Courtstown Housing Development
Little Island, Co. Cork

Stage 1 Road Safety Audit

June 2024

Client	Ruden Homes Ltd.
Project Title	Courtstown Housing Development
Document Title	Report for Stage 1 – Road Safety Audit
Job No.	21008TT
Document No.	21008TT-Doc05

Figure 2.1, Discontinuity of Cycle Lane & Footpath

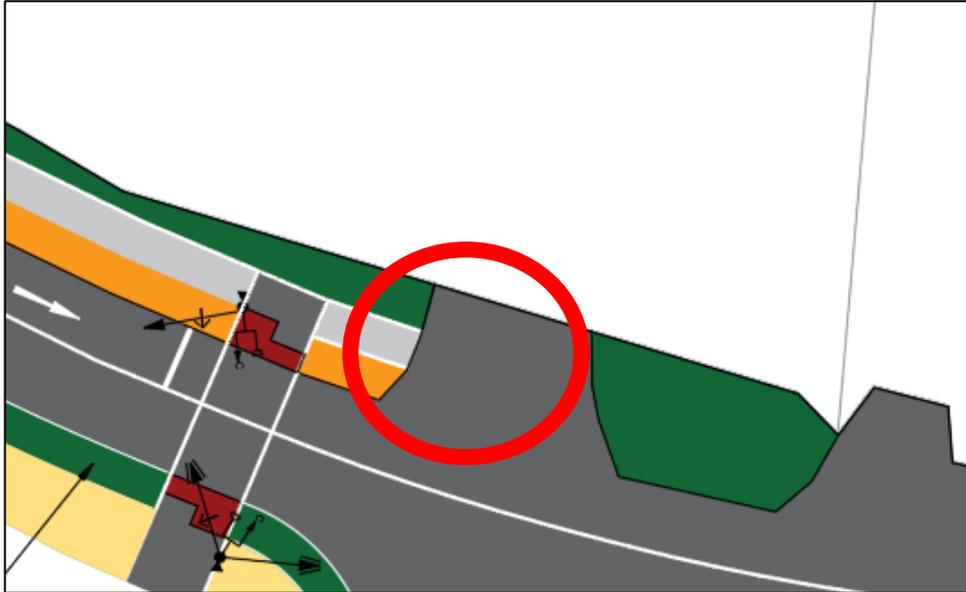
2.1 PROBLEM: DISCONTINUITY OF CYCLE LANE/FOOTPATH

The cycle lane and footpath on the northern side of the western approach ceases following the pedestrian/cycle crossing. This could result in hazardous conditions for both pedestrians and cyclists merging with vehicular traffic. Refer to Figure 2.1.

At detailed design the proposed tie-in should be in line with the proposed council scheme for this area.

Figure 2.2, No Stopline or Traffic Signal

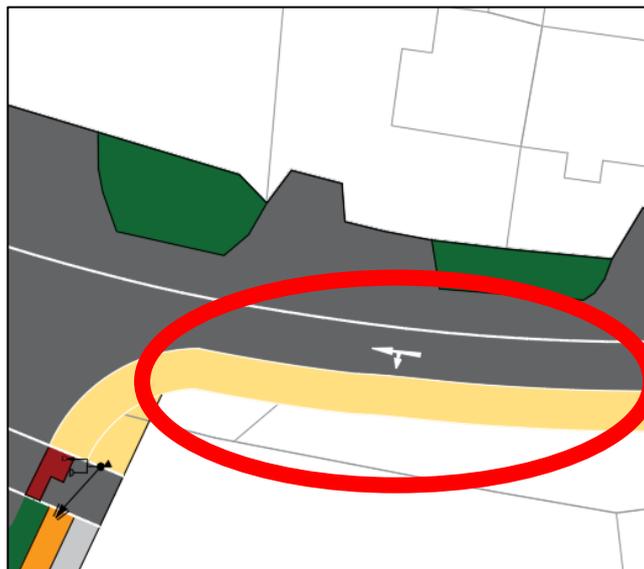
2.2 PROBLEM: NO STOPLINE OR TRAFFIC SIGNAL ON EASTERN APPROACH

The eastern approach road has no traffic signals or stop line at the proposed signalised junction. This could result in traffic approaching from the east and not stopping at the junction putting other vehicles, pedestrians and cyclists at risk. Refer to Figure 2.2.

Ensure a stop line and traffic signal is included in all directions of the junction.

Figure 2.4 Eastern Approach shared surface width

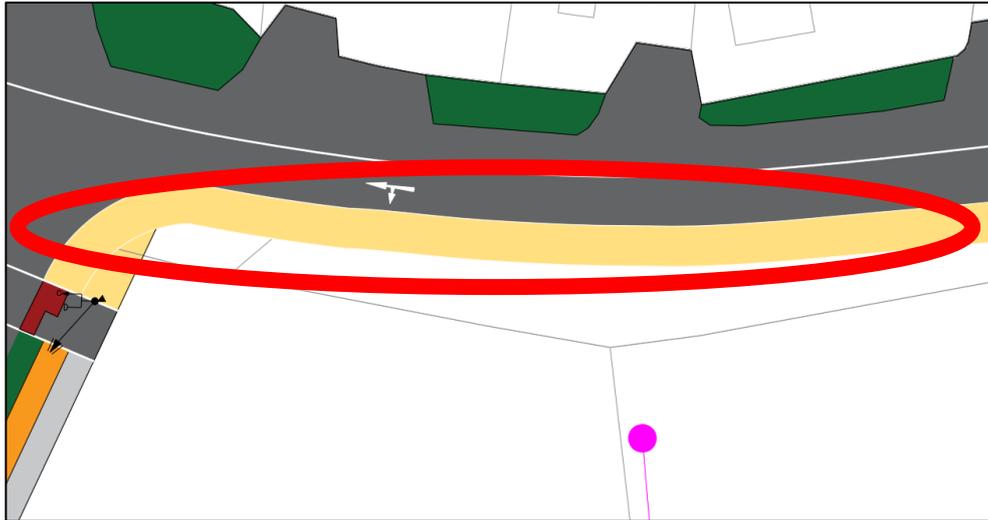
2.4 PROBLEM: SHARED SURFACE WIDTH OF EASTERN APPROACH

The shared surface width along the eastern approach is not in line with the proposed council's scheme for the Courtstown area. This could result in collisions between cyclists and pedestrians travelling on this surface.

The shared surface width should be altered to reflect the proposed Council Scheme.

Figure 2.5 Traffic signals in the middle of the cycleway

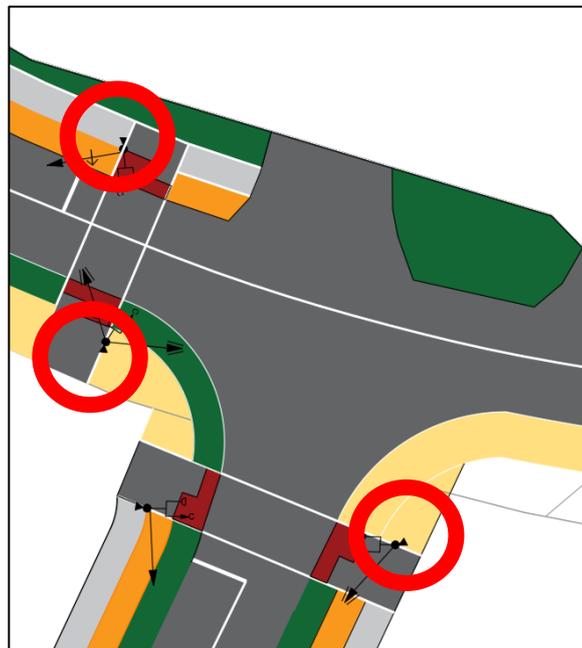
2.5 PROBLEM: TRAFFIC SIGNAL POLE IN CYCLEWAY

Traffic signal poles are shown located between the footpath and the cycle lane within the travelled area. This could lead to incidents for the visually impaired and cyclists.

The designers should consider relocating the traffic signals to areas which do not obstruct any road users.
